SERVICE INSTRUCTION SI0017 Rev D Page 1 of 8

SUBJECT: Retrofit Cowl Flap Installation

MODELS AFFECTED: CC11-100 S/N 00001 thru S/N 00092, S/N 00097, S/N 00099, S/N00108, S/N 00112 S/N 00184 and S/N 00186.
 CC11-160 S/N 00093 thru S/N 00143 excluding S/N 00121, S/N 00133 and S/N 00137.

FIGURE 1 - CC11-160 Cowl Flap Retrofit Template Location

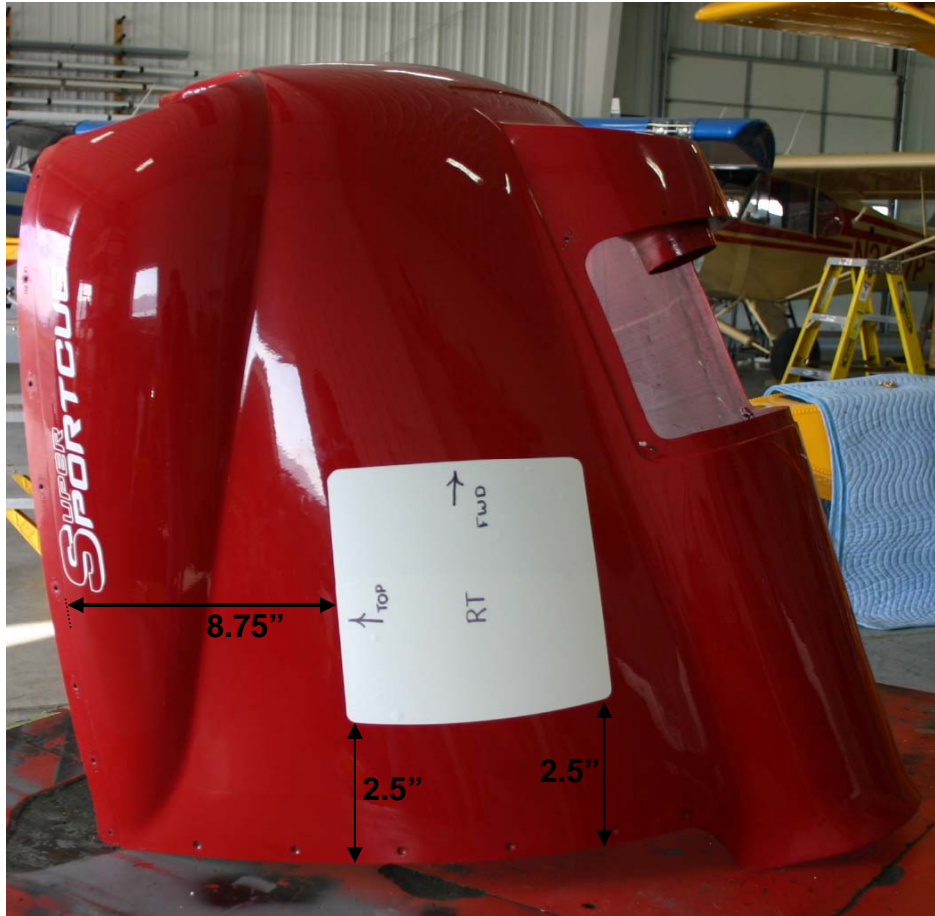
Install templates (PC53599-001) on both sides of the bottom cowl. With a flat edge placed along the molded edge (seam where top and bottom cowls meet) of the bottom cowl, measure 9.5" down to the top edge of the template. Measure 5" forward of the aft edge of the cowling to each corner of the template. Refer to Figure 1 below.

FIGURE 4 - Test Fit of the Cowl Flaps

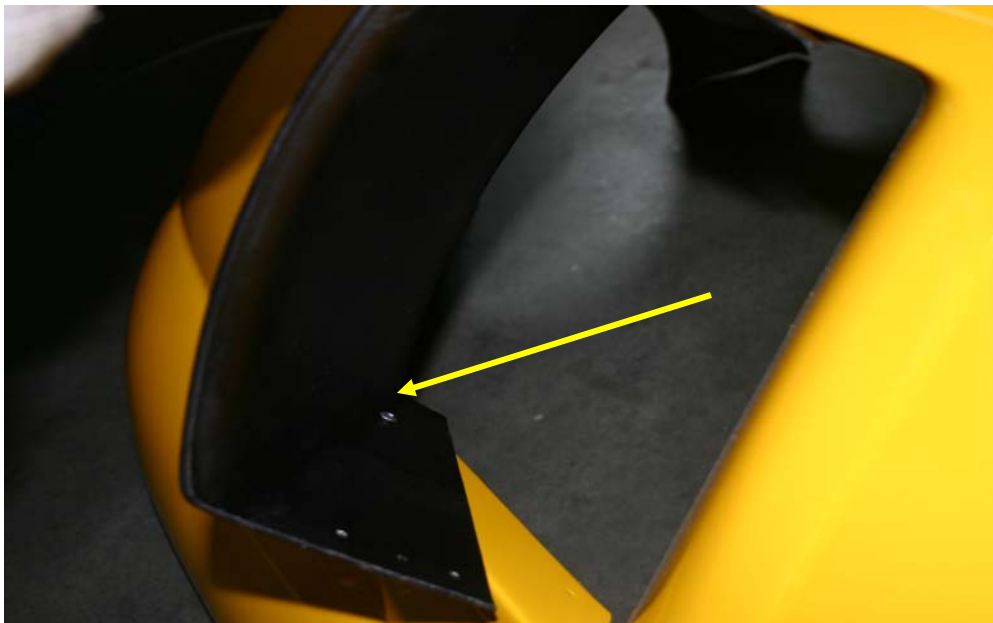
13. Attach the Cowl Flaps (SC53032-001 or PC53005-001 and SC53032-002 or PC53005-002) into the appropriate frames using two (2) AN526C632R6 (screw), four (4) AN960-6L (washer) and two (2) AN363-632 (high temp. lock nut) in the pre-drilled holes in the cowl flap frame. Do not set the position of the cowl flap at this time. Allow the cowl door to move freely in the frame. Refer to Figure 4.

FIGURE 5 – Fuel Routing Change CC11-100 except Executive Glass

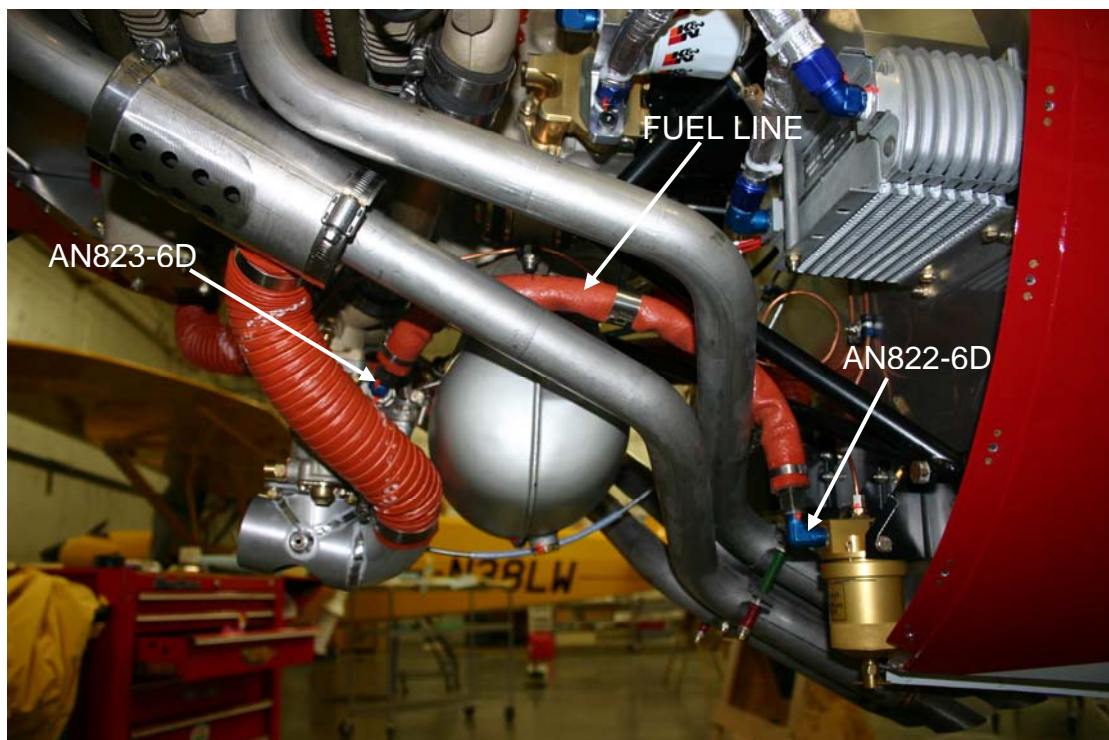
Remove the fuel line and the straight AN816-6D fittings on the gascolator and carburetor. Replace the gascolator fitting with the AN822-6D 90° fitting and the carburetor fitting with the AN823-6D fitting. Reinstall the fuel line so that it routes up and over the exhaust securing the fuel line to the engine mount as shown in Figure 5.

FIGURE 6 - Test Fit of the Cowling

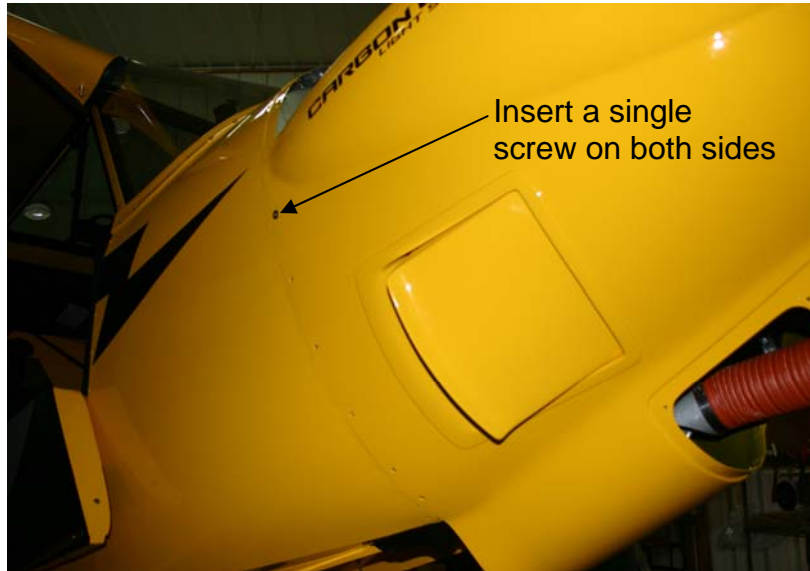
15. Test fit the lower engine cowling using one screw in each corner to hold the cowl in place. Refer to Figure 6.

FIGURE 7 - Cowl Flap Clearance

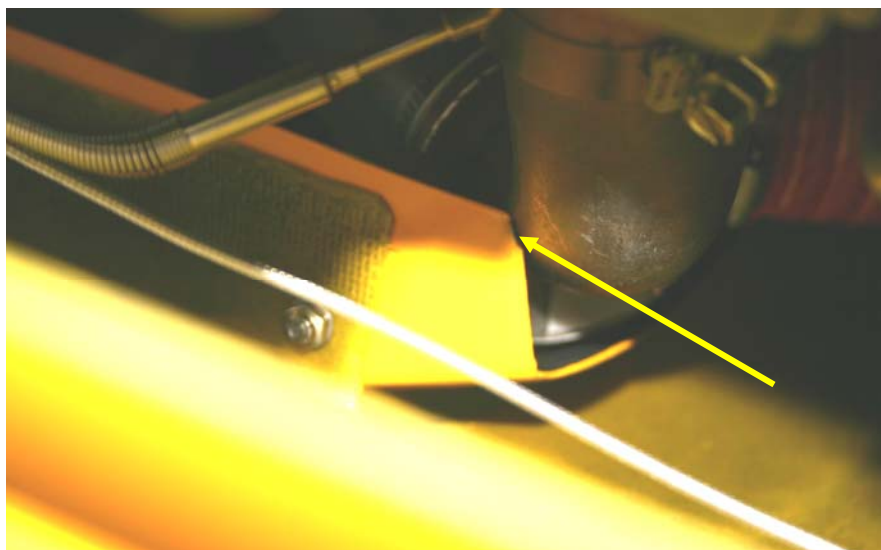
16. Visually inspect the cowl doors in all three positions making sure they do not contact the engine or its components. Refer to Figure 7.

If the cowl door contacts the engine or its components, trim as needed for clearance. There should be at least ½ "of clearance between parts to allow for engine movement.
